From: OConnor, Karina [<mailto:OConnor.Karina@epa.gov>]
Sent: Friday, June 06, 2014 10:53 AM
To: Yoon, Andrew U@DOT
Cc: Rongsheng Luo; Berry, Laura; Bohnenkamp, Carol
Subject: Urgent Revised Quantitative PM10 Hot Spot Analysis for High Desert Corridor Project for May 27, 2014 TCWG Meeting

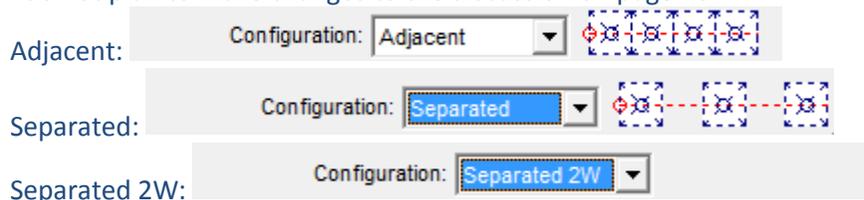
- On page 16, where the AERMOD volume sources setup is described, the width and Sigma-Z0 (Szinit) are described, but not the spacing of the volume sources. The sentence in bold below leaves it unclear whether the spacing is correct. Could you add more specific language describing the spacing of the volume sources?
*Individual emission for roadway or HSR feeder service was set up in the model as a line-volume source. With the help of GUI of the Lakes AERMOD View, line-volume sources were created along the roadway and HSR feeder service alignments, with each width set to match the width of the roadway width or HSR rail width. A release height for each roadway source was estimated as a weighted average of non-truck and truck traffic based on the formula in Appendix J of the Guidance. **It should be noted that each line-volume was then further divided into multiple individual and adjacent volume sources whose side equals to the width defined for each roadway or rail facility.** Each line-volume source was initially assigned with an emission rate of 1 g/s; but was further directed to vary emission rates on an hourly basis for each period according to the rates summarized in Attachment D.*

2nd bullet: As recommended by the EPA Guidance, all volume sources in this Analysis are configured as "adjacent." For reference, there are three options in Lakes AERMOD View for configuring a line source parameter, represented by volume sources: adjacent, separated, and separated 2W. Graphical representations for these options are shown below. "Separated 2W" does not show any illustration; but individual sources are separated by a spacing equal to twice the width. If this clarification is satisfactory, I do not plan to make changes to the discussion on page 16.
